Старая модификация

Новая модификация

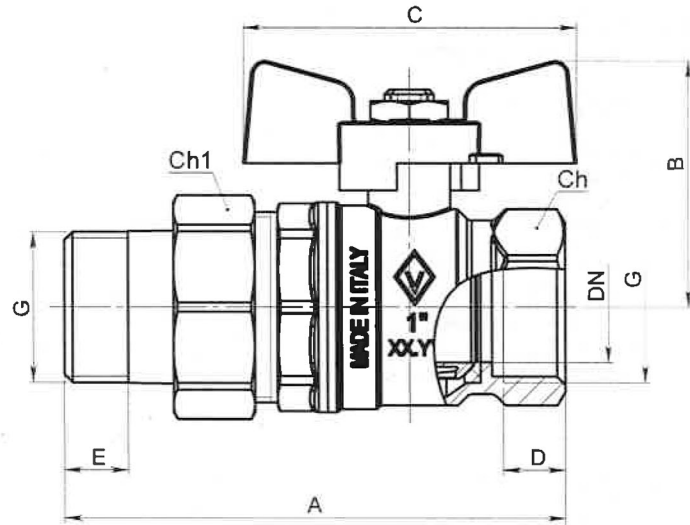
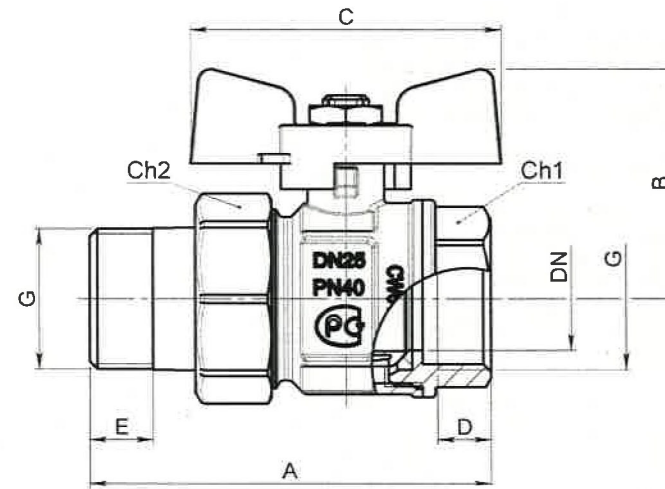
DN	G	A	B	C	D	E	Ch	Ch1	PN
15	1/2"	83.5	39	53	9	10	25	30	50
20	3/4"	96	42.5	53	11	12	31	37	40
25	1"	110.5	53.5	73	13.5	14	38	46	40
32	1 1/4"	128	59.5	73	14.5	15	47	52	30

DN	G	A	B	C	D	E	Ch1	Ch2	KV	PN
15	1/2"	70	39	53	9	10	25	30	16.3	50
20	3/4"	81	42.5	63	11	12	31	37	29.5	40
25	1"	94.5	53.5	73	13.5	14	38	46	43	40
32	1 1/4"	110	59.5	73	14.5	15	47	52	69	30
